SUBJ: Cedar Hill Road Subdivision (1512-1524 Cedar Hill)-#25-07SUBD

Reference: 1512 & 1524 Cedar Hill Road Subdivision
TMP's #39-00-00646-00-8 and #39-00-00649-00-5
Preliminary/Final Land Development Application

Pursuant to your request, Gilmore & Associates, Inc. performed a review of the preliminary submission for land development for the above-referenced project. Upon review, we offer the following comments for consideration by the Lower Gwynedd Township Board of Supervisors:

1512 & 1524 CEDAR HILL ROAD (STA #6571)

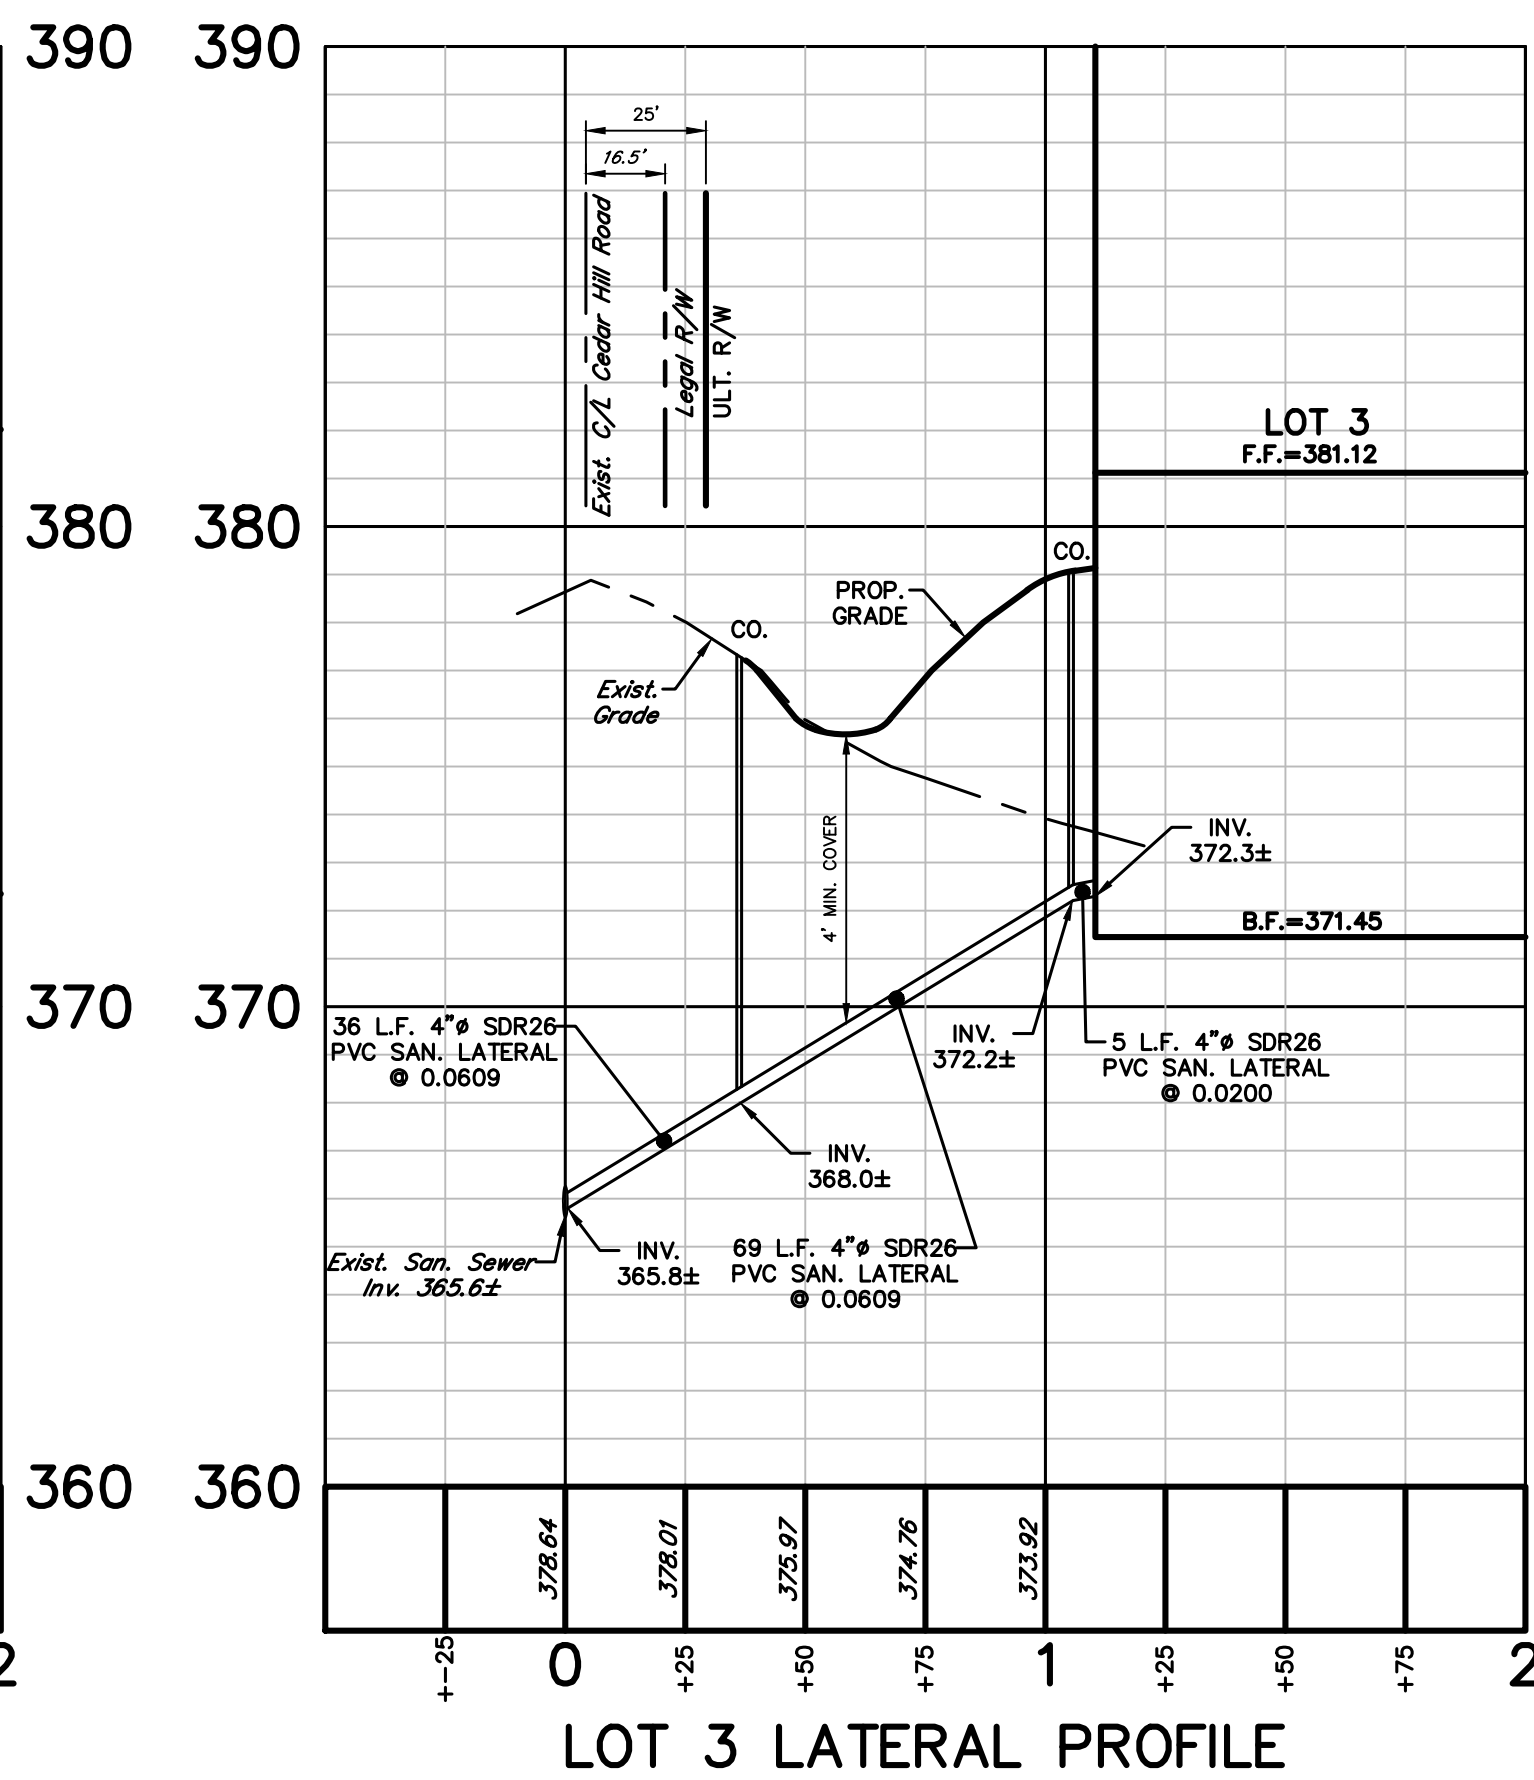
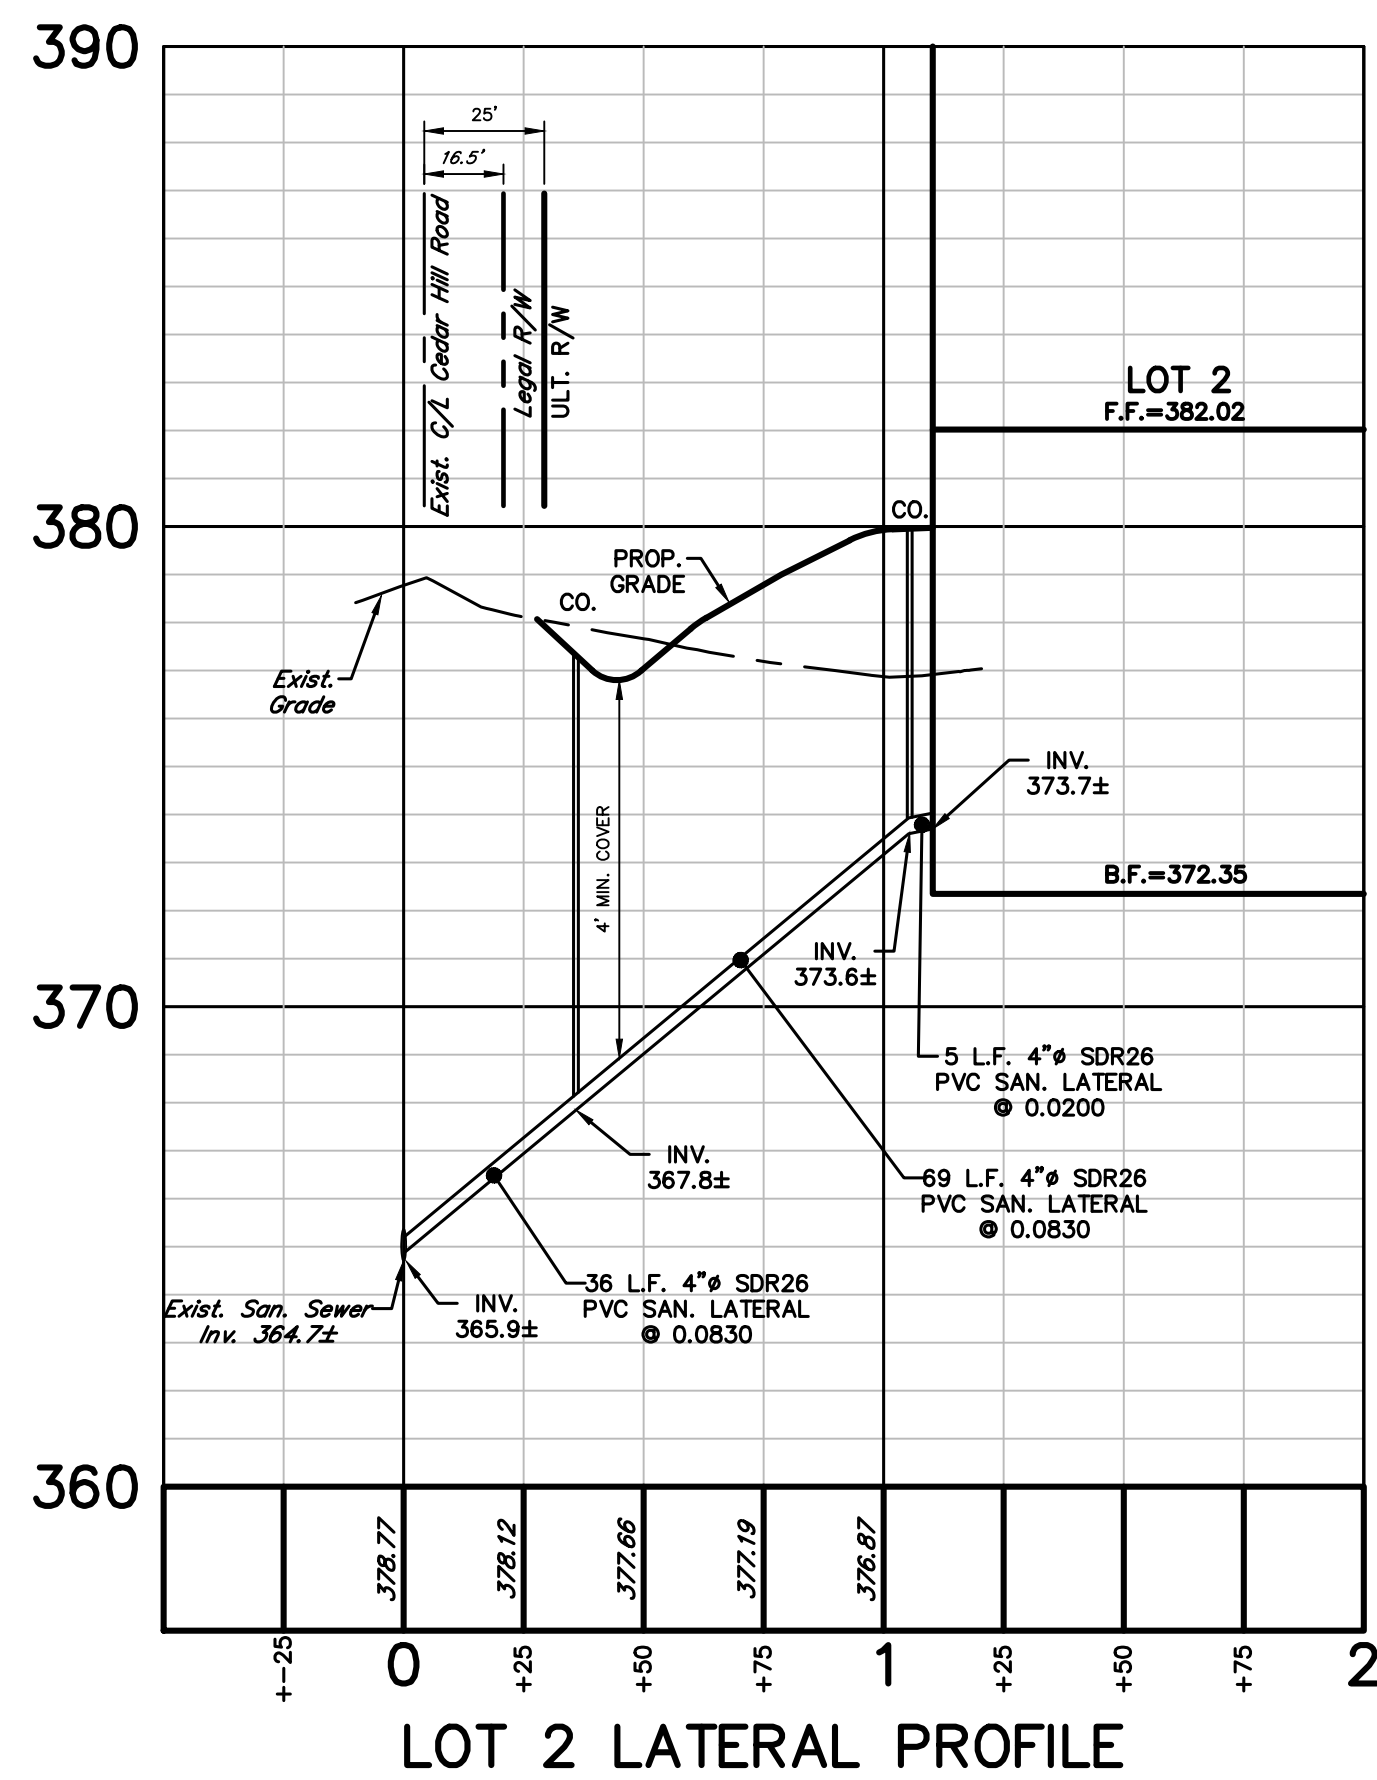
3. Additional details for the proposed driveways to lots 1 to 4 must be added to the plans. The driveways must be designed in accordance with **Section 1230.38** of the **Subdivision and Land Development Ordinance** with respect to grades and widths. The details should include the following:
 - a. Driveway tie-in radii.
 - b. Driveway width(s).
 - c. Driveway grades, as well as the cross-slope grades of the roadway.
 - d. Location and distance of driveway grade breaks.

Response: The requested information is provided on Sheet 15.
